Access Compliance Report

Public Rights-of-Way

(Curb Ramps)

Intersection ID: 52999	Main Street: VICTORIA_BROOK_LN	Cross Street: GRANT_MARTIN_DR	Location: SW
ADA ID: 2D4CF6A953AE	Ramp Type: Perp	Initial Pass/Fail: Fail	Overall Compliance: No
			Severity Score: 8.75
Codes/Mitigation Info/Possible Solution		Field Measurements/Component Compliance

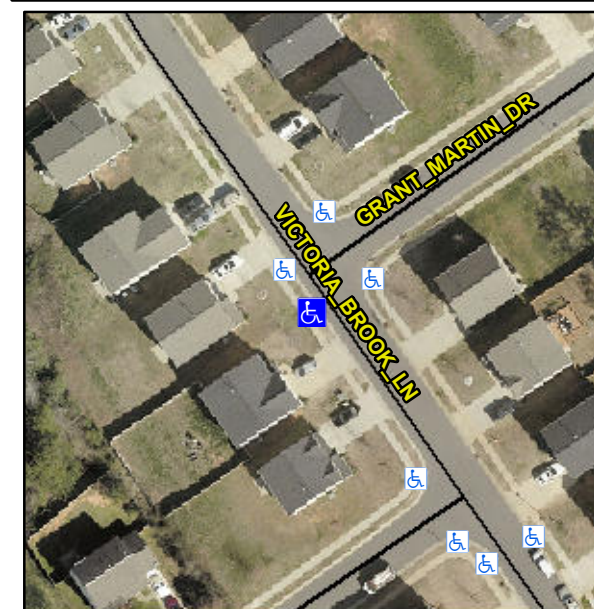
Not Found, R304.5.1

Compliance	Description	Data	Compliance	Description	Data
N/A	Ramp Length (in)	47.0	Yes	Ramp Slope (%)	6.4
No	Ramp Width (in)	47.5	Yes	Ramp XSlope (%)	1.1
N/A	Flare Type LT	N/A	N/A	Flare Type RT	N/A
N/A	Flare Slope LT (%)	N/A	N/A	Flare Slope RT (%)	N/A
N/A	Flare Traversable LT?	N/A	N/A	Flare Traversable RT?	N/A
N/A	Landing Length (in)	N/A	N/A	DWS Provided?	N/A
N/A	Landing Width (in)	N/A	N/A	DWS Contrast?	N/A
N/A	Landing Slope (%)	N/A	N/A	DWS Length (in)	N/A
N/A	Landing X Slope (%)	N/A	N/A	DWS Full Width?	N/A
N/A	Landing Curb? (Y/N)	N/A	N/A	DWS Offset (in)	N/A
N/A	Shared Landing?	N/A			
N/A	Gutter Ponding?	N/A	N/A	Gutter Slope (%)	N/A
N/A	Gutter Lip Ht (in)	N/A	N/A	Gutter X Slope (%)	N/A
N/A	Painted X Walk1?	No	N/A	Painted X Walk2?	N/A
	X Walk 1 Direction	To E		X Walk 2 Direction	N/A
N/A	X Walk 1 Width (in)	N/A	N/A	X Walk 2 Width (in)	N/A
	X Walk 1 Slope (%)	3.4		X Walk 2 Slope (%)	N/A
	X Walk 1 X Slope (%)	2.0		X Walk 2 X Slope (%)	N/A

Remove & Replace Entire Ramp.
